UNITED STATES PATENT AND TRADEMARK OFFICE

APPLICATION NO.	FILING DATE	FIRST NAMED INVENTOR	ATTORNEY DOCKET NO.	CONFIRMATION NO.
09/421,575	10/20/1999	ICHIRO KASAI	15162/00910	4346

Office Action Summary	Application No. 09/421,575	Applicant(s) KASAI, ICHIRO	
	Examiner Craig Curtis	Art Unit 2872

DETAILED ACTION

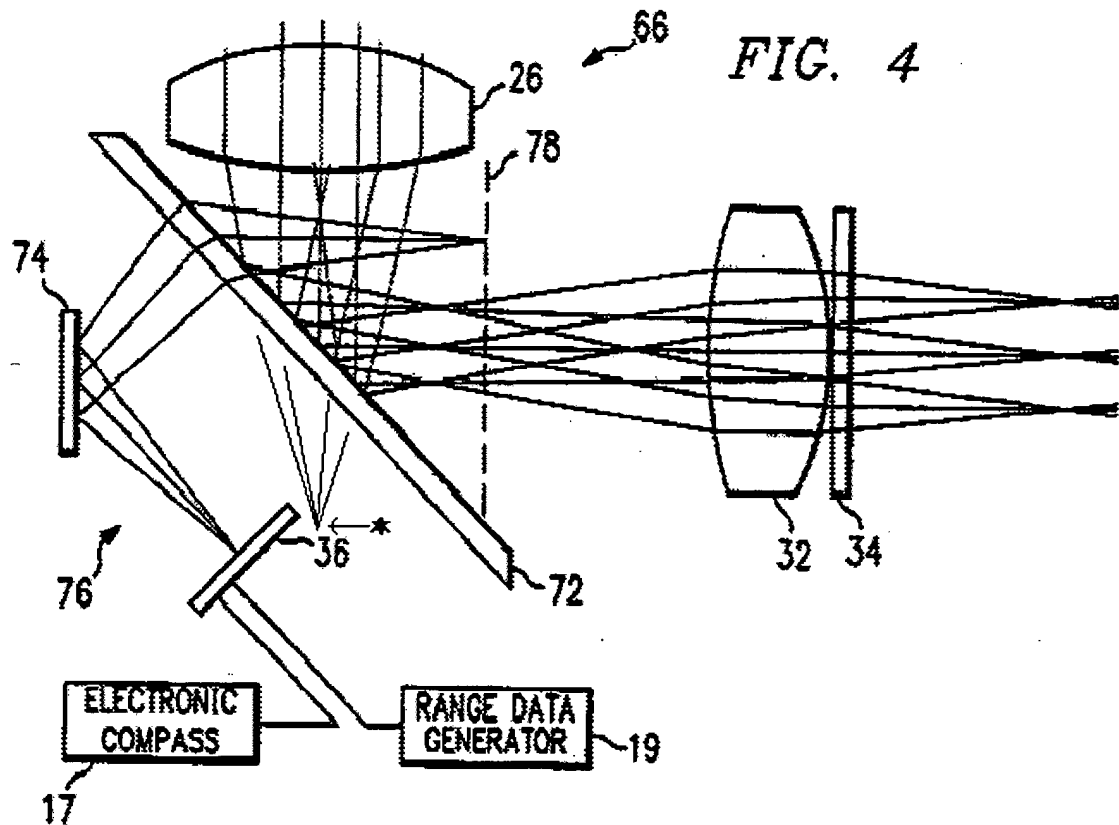
a hologram combiner (Fig. 4, 72) comprising a reflective-type hologram (a reflective- *and* transmissive-type, or transflective-type, actually) and having an optical power for constructing an equivalent surface (78) which is optically equivalent to the image surface at a different position than the image surface as viewed from the pupil (See annotated Fig. 4 below: esp. <---*); and

an information display device (76) for displaying information on the equivalent surface--
EXCEPT FOR the additional teaching wherein the hologram combiner transmits light from the image and reflects light from the information display device so that the image can be viewed with the information overlaid thereon. It is noted, however, that Wallace does disclose wherein the hologram

combiner reflects light from the image and transmits light from the information display device so that the image can be viewed with the information overlaid thereon, wherein the information displayed on the information display device is directed to the pupil as a virtual image (not presently depicted in the drawings of the instant invention).

the pupil.” That this is the case can be seen by reference to the annotated Fig. 4 of Wallace provided above. In this case, the equivalent surface is 78, and the image surface (virtual) is as depicted by (<---*) As clearly depicted in said annotated Fig. 4 of Wallace, equivalent surface 78 is both optically equivalent to the image surface (identified by <---*) and at a different position than the image surface as viewed from the pupil.

As is clearly set forth in Fig. 4 of the Wallace reference, the hologram combiner (72) is both reflective and transmissive (read: transfective): reflecting the light from the image and transmitting the light from the information display device (76). As is clearly set forth in the rejection of claims 1 and 10 above, one of ordinary skill in the viewing optical system art would certainly consider obvious the rearrangement of the relative positions of the information display device and light from the image (including, of course, lens 26), one to the other, for at least the purpose of, for the sake of example, increasing the brightness of light from the information display device via reflection from said hologram combiner, as opposed to the brightness of same realizable via transmission through said hologram combiner.

The hologram combiner (72) taught by Wallace not only has optical power (as can clearly be seen in Fig. 4, in which light diverging from folding mirror (74)--that is, light from said image display device--is made to converge following its transit through said hologram combiner, a result that could only be achieved if said hologram combiner had non-zero optical power); but focuses light from said information display device at plane 78, which is “optically equivalent” to the image surface at a different position than the image surface as viewed from the pupil in the same manner as that constructed by Applicant’s hologram combiner. (It is noted that the manner in which something can be described as being both “optically equivalent” and “at a different position than the image surface as viewed from the pupil” is met by Wallace by broadly interpreting “optically equivalent.”) In addition, as was noted in the previous Office action, Fig. 4 clearly depicts light from the information display device focussing at a different position (i.e., to the left of 78) than light from the imaging lens 26 (which focuses to the left of 78, denominated “common” or not) as viewed from the pupil (although the physical separation between focused information display device light and that from the imaging lens (read: image) is not set out in Wallace).
